# Fuel Tank Shield Rattle Noise

**Service Category** Vehicle Exterior

**Section** Exterior Panels/Trim

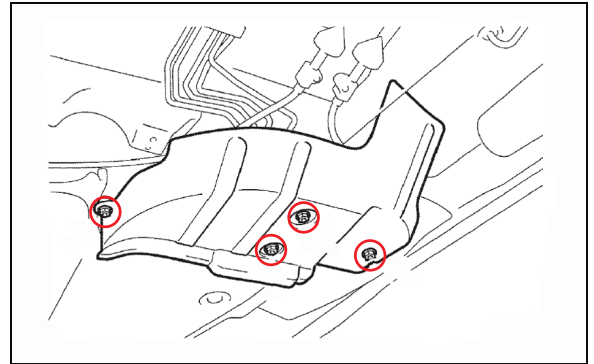
1. Remove the No. 1 fuel tank protector by removing the 4 nuts and then remove the No. 1 fuel tank protector. **Figure 1.**

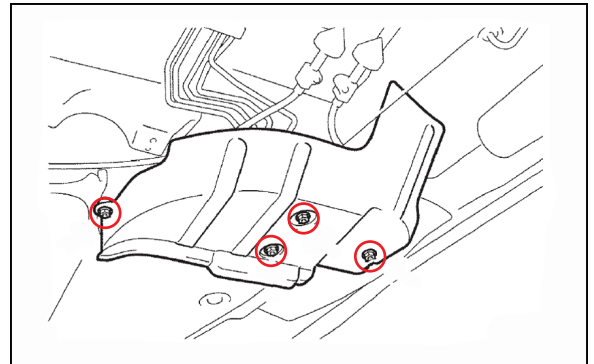
2. Install the No. 1 fuel tank protector with the 4 nuts. **Figure 2.**  
**Torque: 5.5 N\*m (56 kgf\*cm, 19 in\*lbf)**
